470-02-13

Modifications to design of Shoulder,
and Edgeline Rumble Strips (SOL 470-02-05)

This letter is intended to revise the attachments B and C to SOL 470-02-05, "Low Cost Safety Improvements 3R Projects Center, Shoulder, and Edgeline Rumble Strips". After receiving input from the Districts, the following modifications were made to the attached guidelines and drawings:

Attachment B (cont.)
BTSRS Detail (55 MPH or More Posted Speed)
Typical Drawing Detail # 1

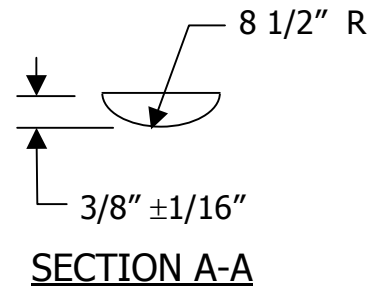
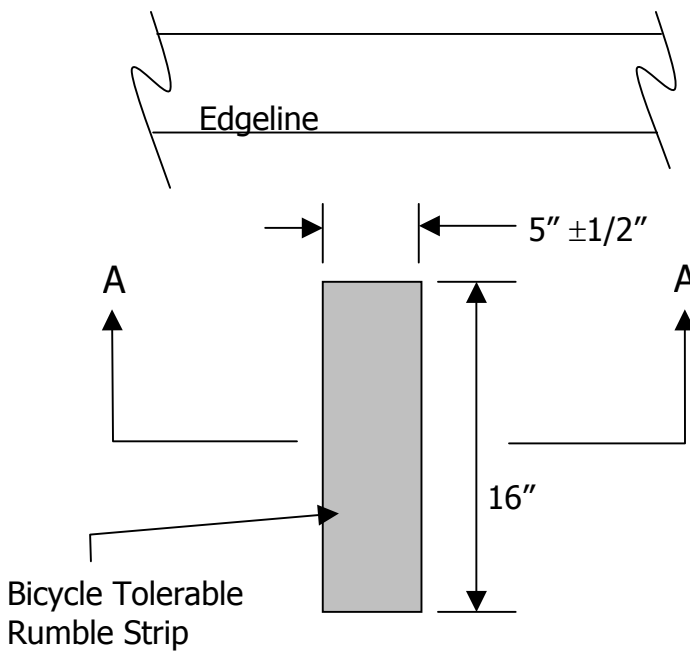
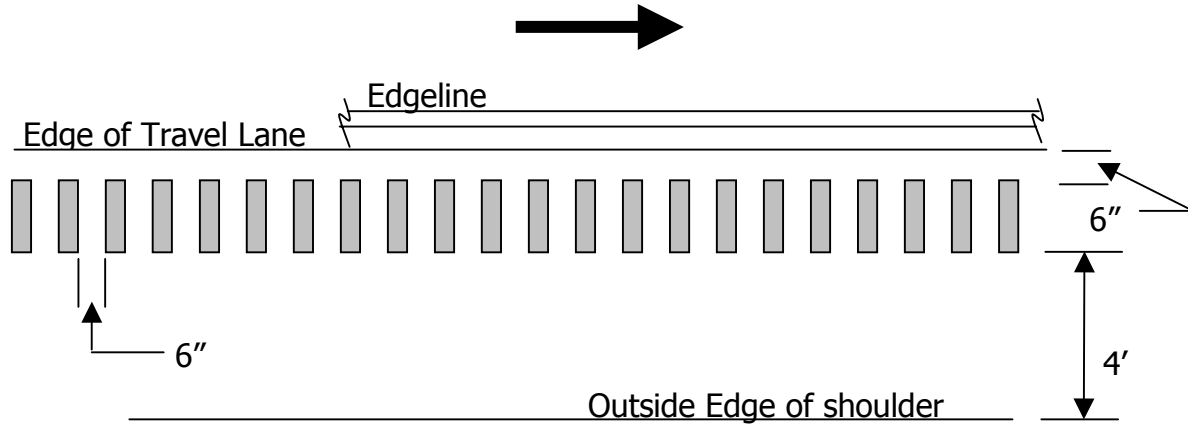
- Radius of rumble strip cut changed to 8-1/2" R in order to achieve the desired depth and width of cut.
- Attachment B Drawing Details "Edge of Pavement" changed to "Edge of Travel Lane" to better indicate proper placement of rumble strip.
- Minor typographical and drawing changes for clarification.

Attachment C (cont.)
Edgeline Rumble Strips
Typical Drawing Detail # 1

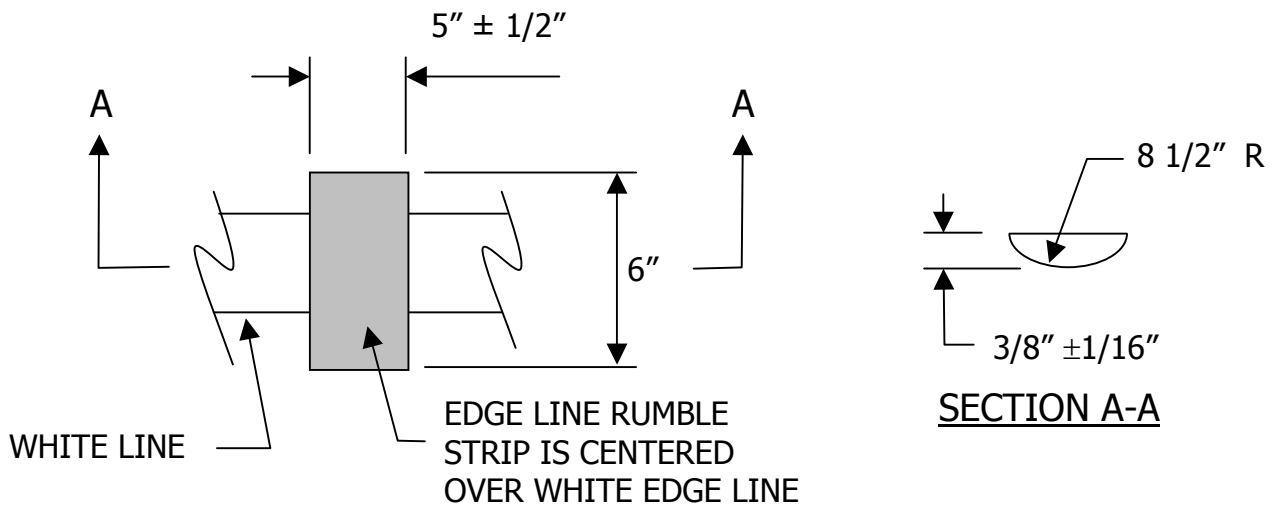
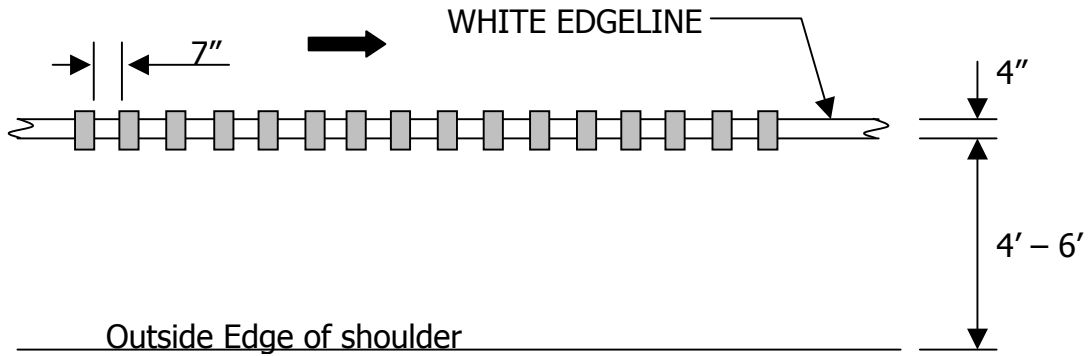
- Radius of rumble strip cut changed to 8-1/2" R in order to achieve the desired depth and width of cut.
- Depth of rumble strip cut changed to 3/8" with a tolerance of 1/16" in order to have the same depth and tolerance as the Bicycle Tolerable Shoulder Rumble Strips for constructability and efficiency.
- Minor typographical and drawing changes for clarification.
